Town of Hilton Head Island
Design Review Board Meeting
Tuesday, December 14, 2021 – 1:15 p.m.
AGENDA

i. Waterfront Restaurant, DRB-002657-2021

ii. Heritage Academy Pavilion, DRB-002658-2021

CRAB RESTAURANT
 SITE IMPROVEMENTS PLAN

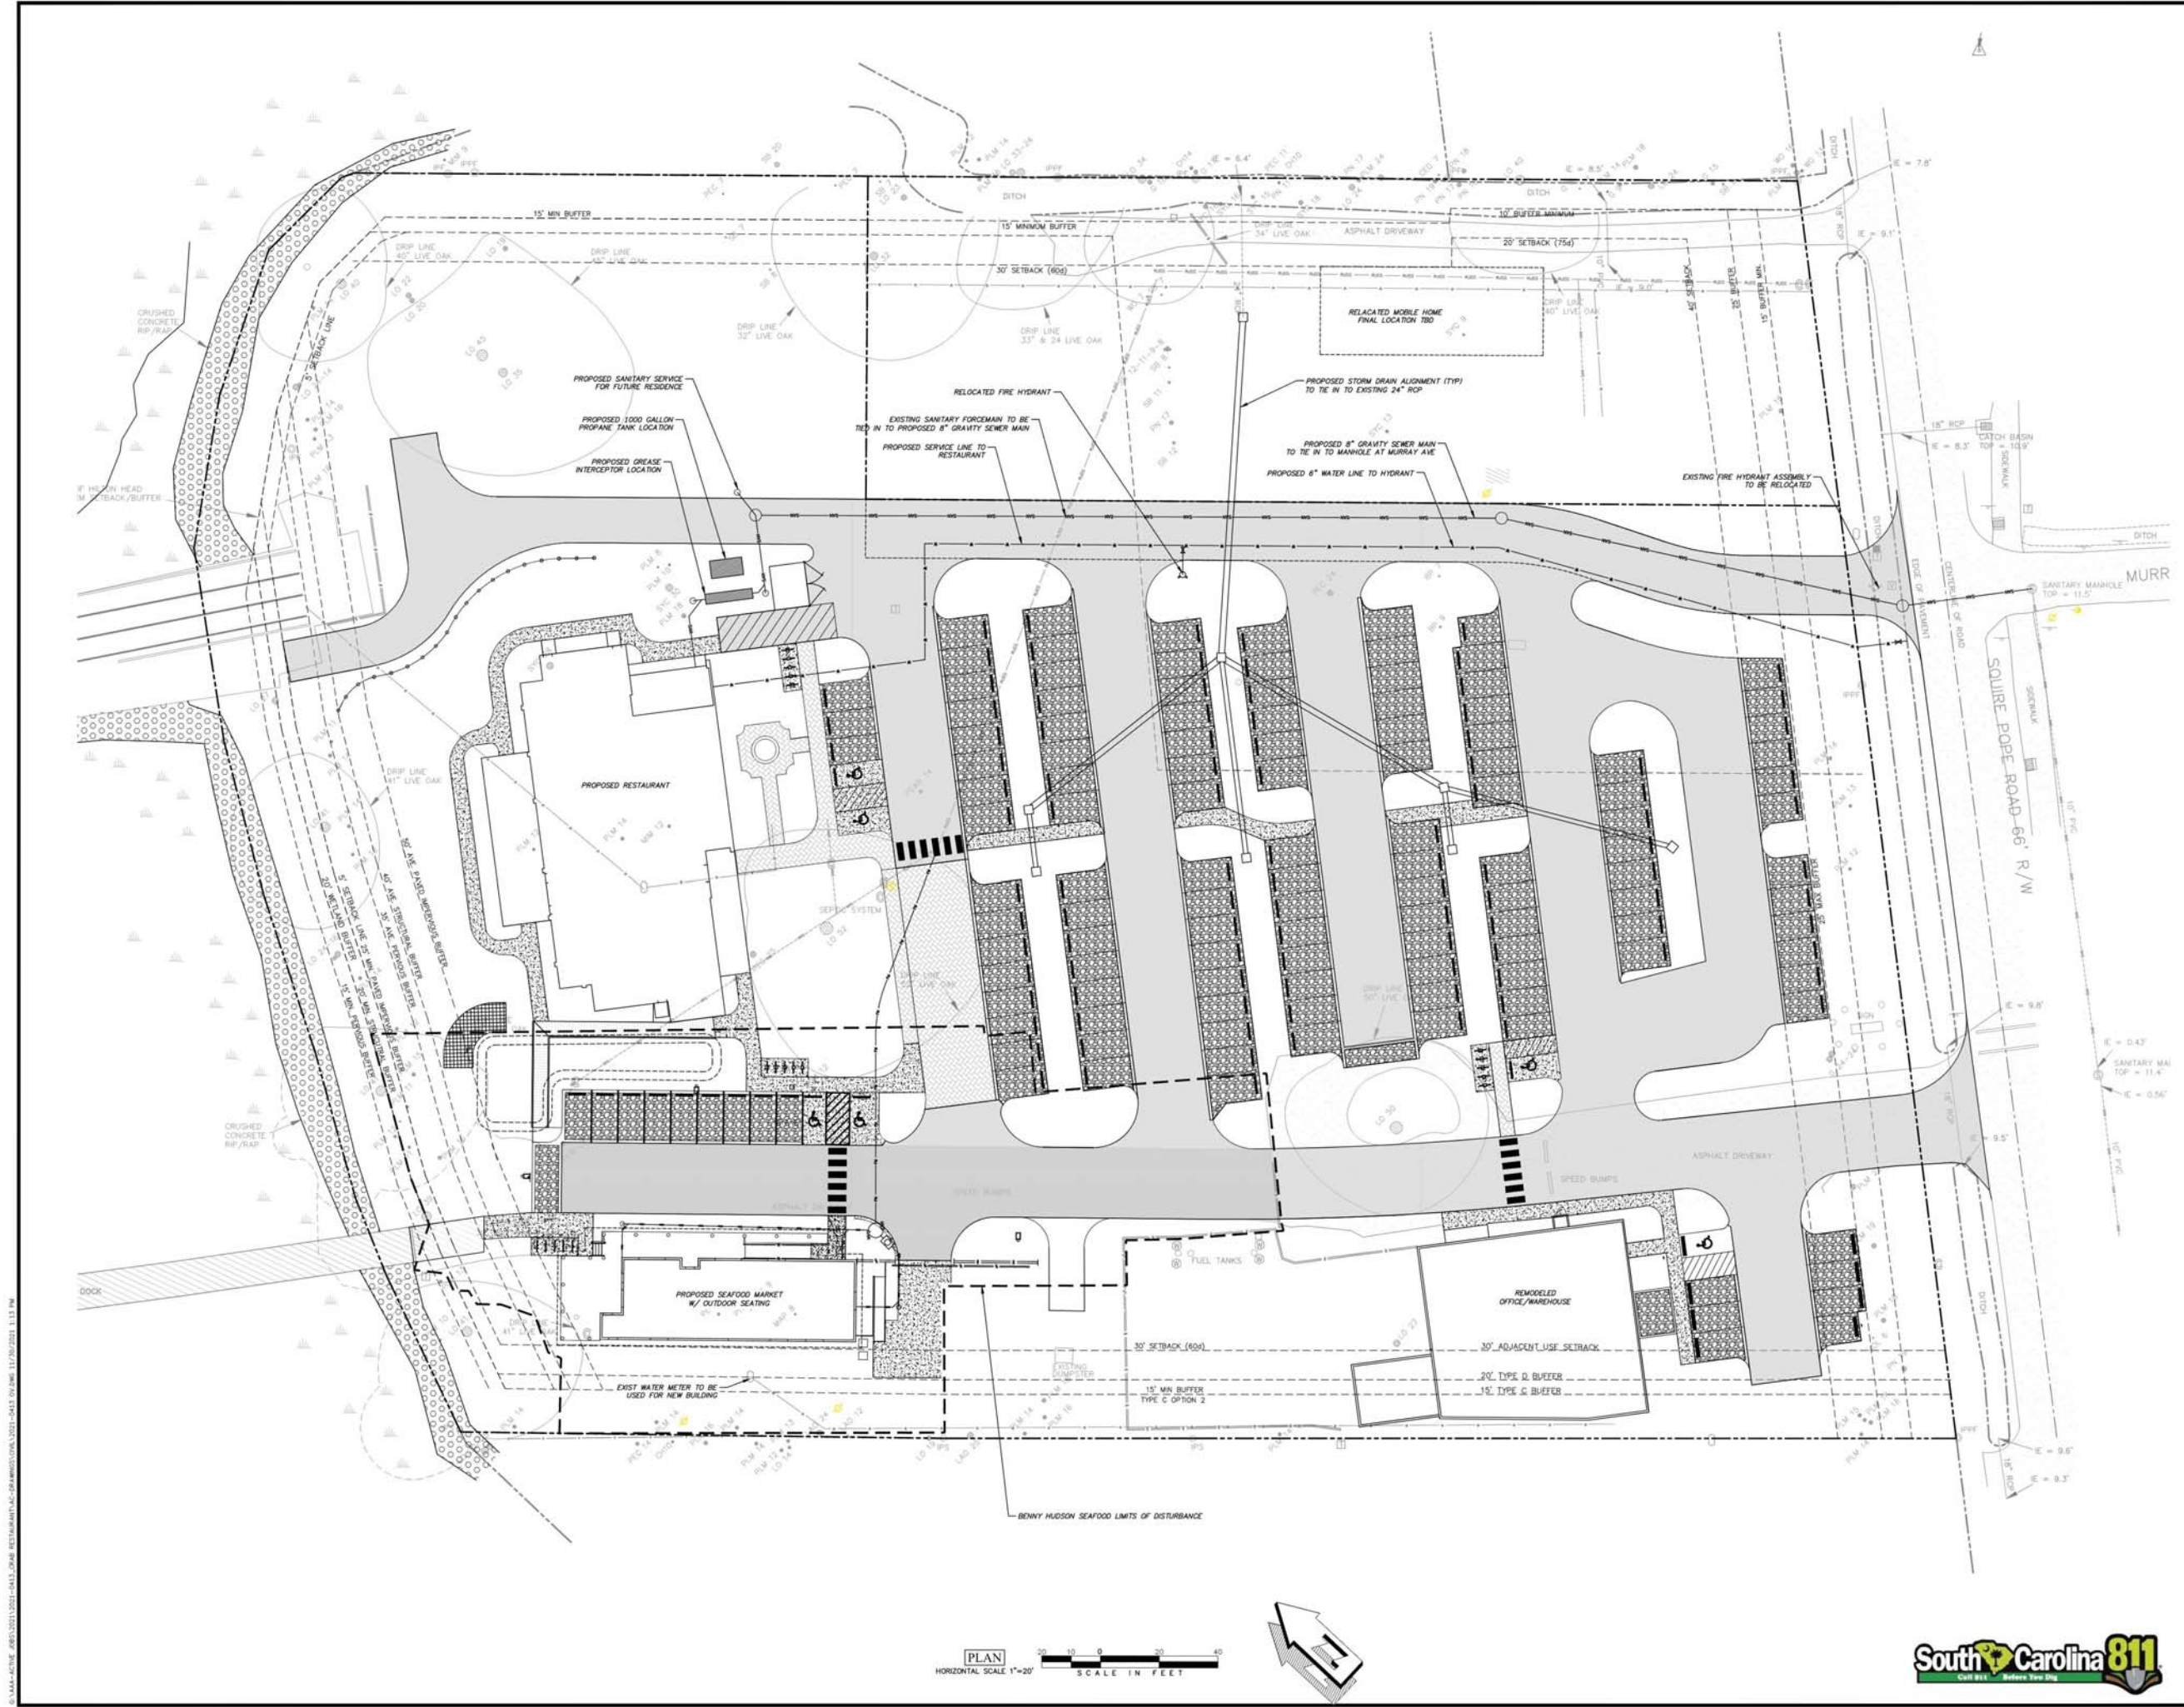
1. Reduce the amount of lawn area on the site.
2. Specify that the utility line under the 53 LO shown on the "Site Improvements Plan" it to be abandoned in place.
3. Provide a tree protection plan showing tree protection fence and specifying pre / post construction fertilization and mycor treatment for the 53" LO.
4. Provide tree lighting details that do not damage the tree.

DRAWING TITLE
KEY SHEET

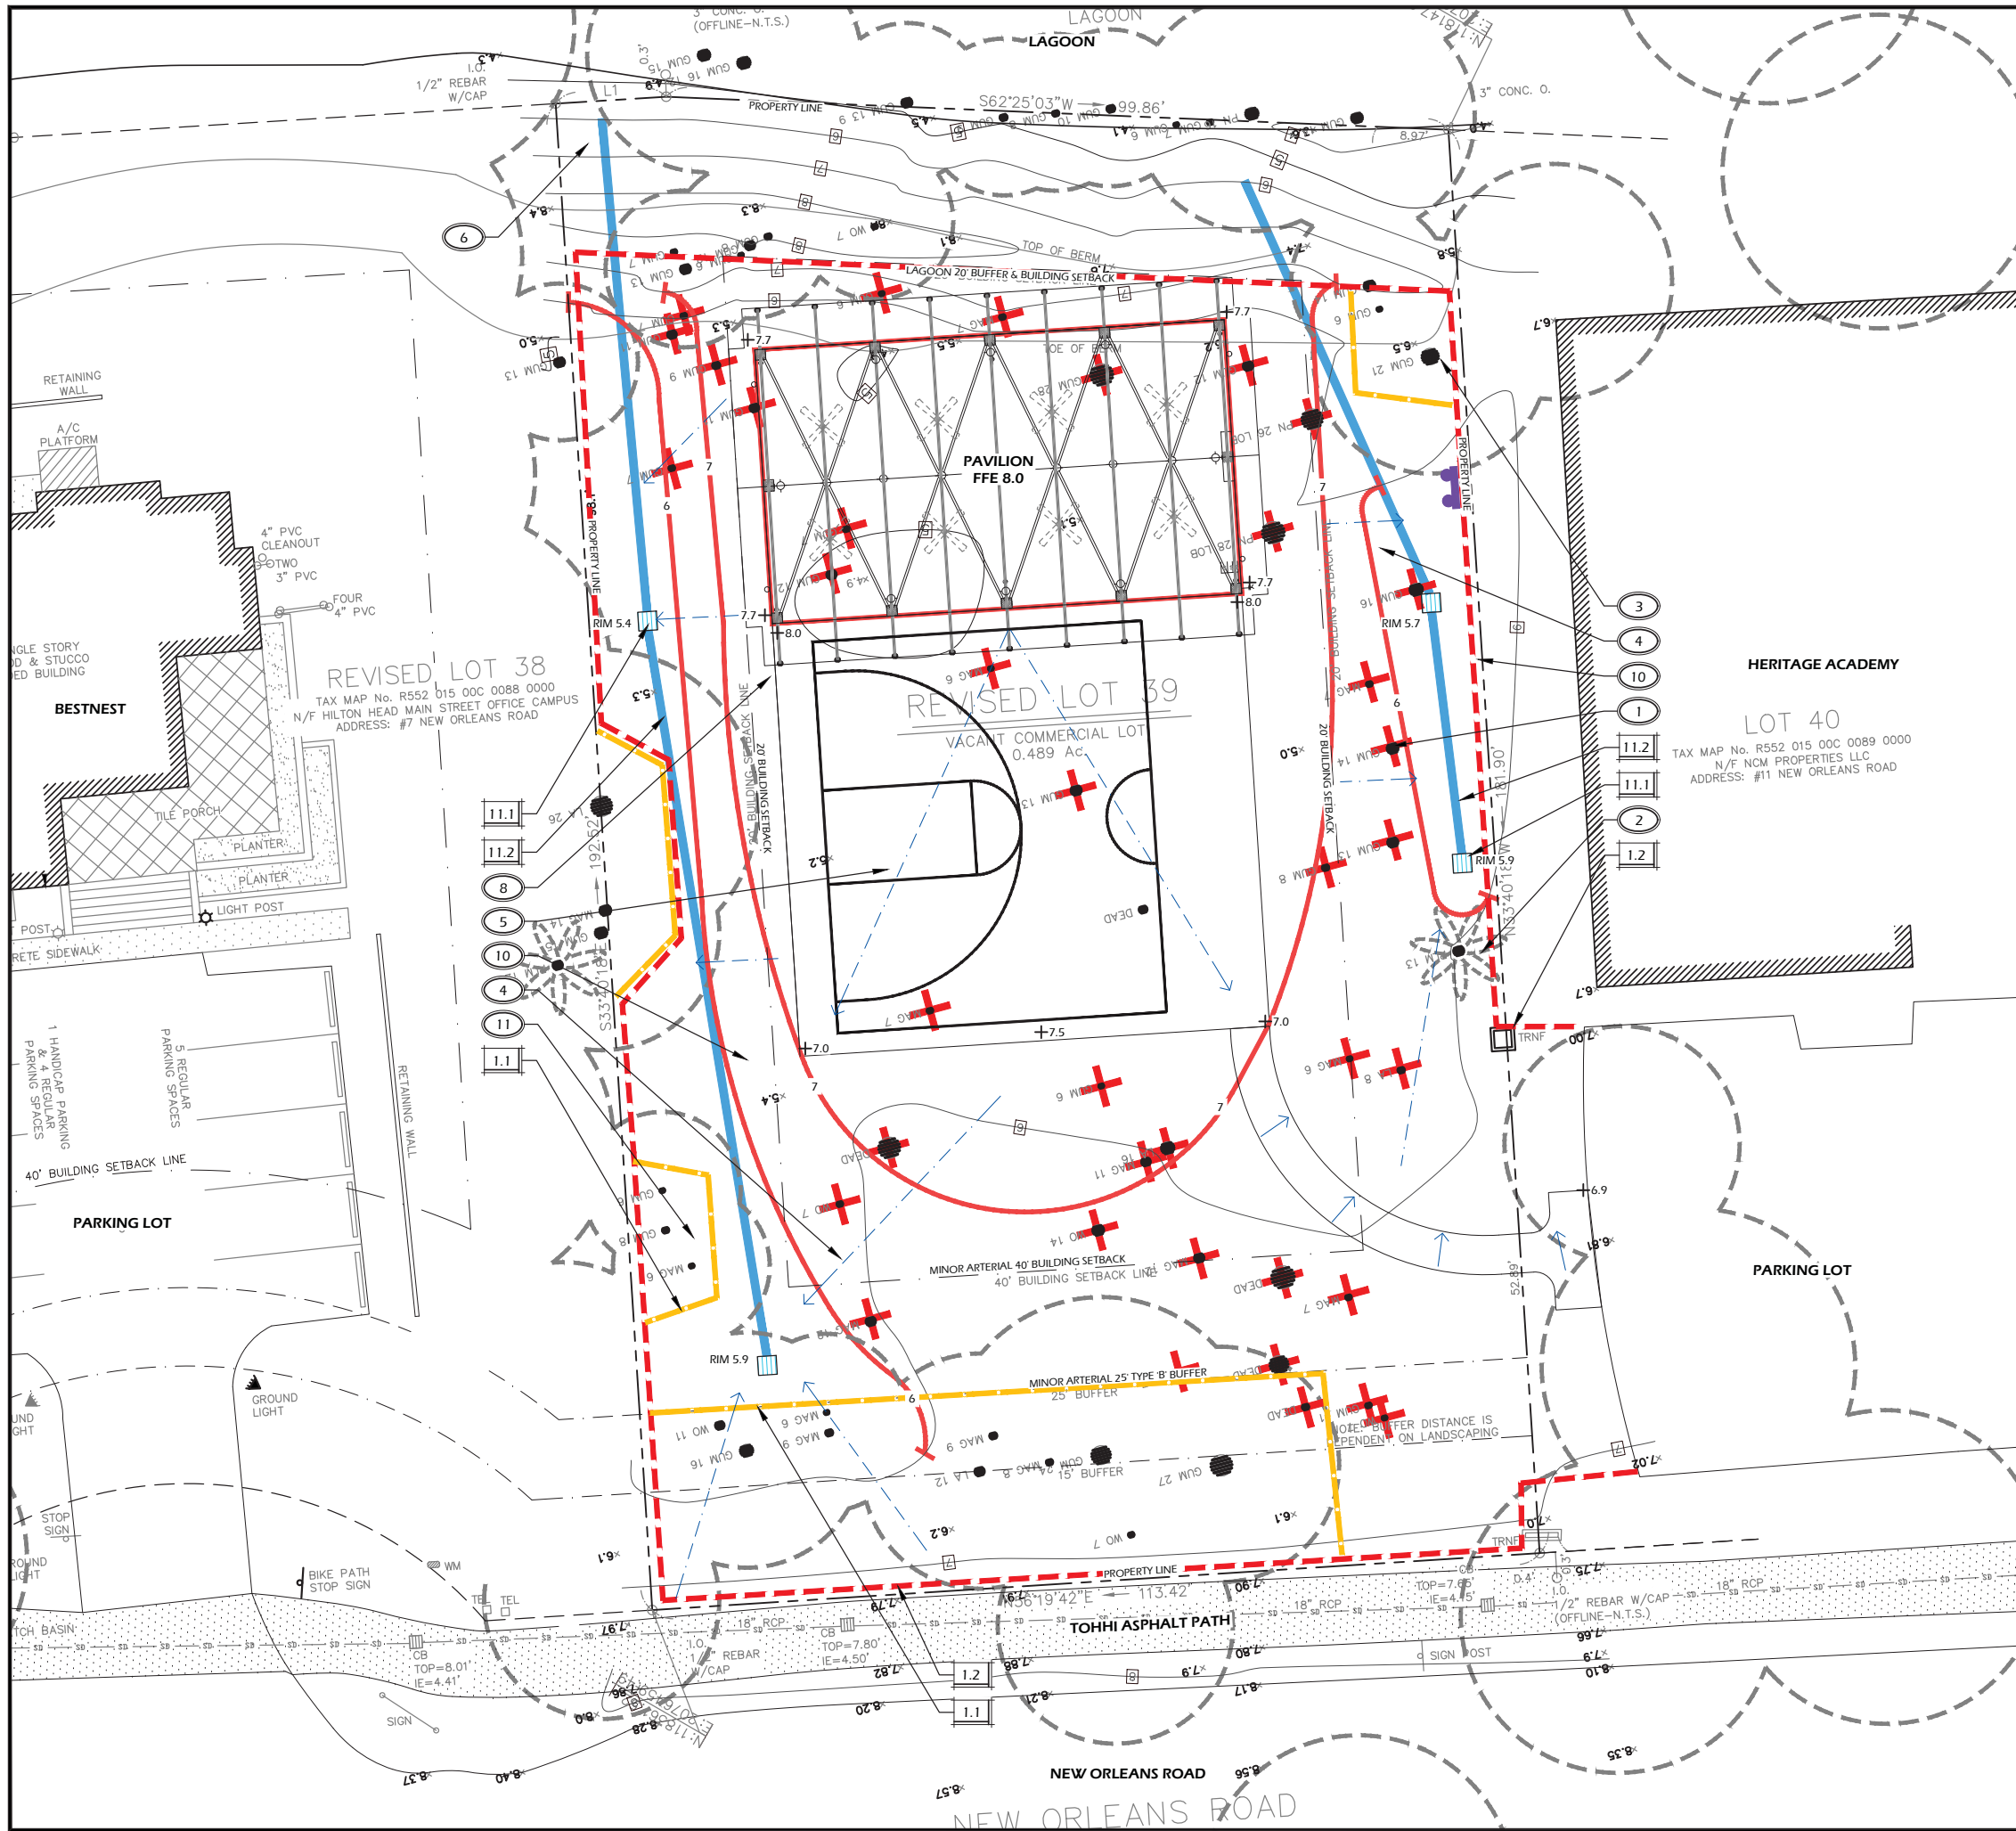
1. Revise the site plan to better function for pedestrians and with the existing building.
2. Revise the storm drains to better preserve existing vegetation.
3. Conceal conduits in the pavilion.
4. Revise the landscape plan to eliminate sod in the street buffer.
5. Preserve the magnolias in the street buffer.

1. Revise the site plan to better function for pedestrians and with the existing building.
 - a. We have revised the landscape and walkway design to identify the entrance to the pavilion site from the end of the school parking lot, and to delineate this transition. No exterior access from the academy is available to create an access form the rear of the building, and there is not space for a sidewalk between the existing parking and the building.

2. Revise the storm drains to better preserve existing vegetation.
 - a. The storm drains have been revised and notes have been added to minimize disturbance around remaining trees.
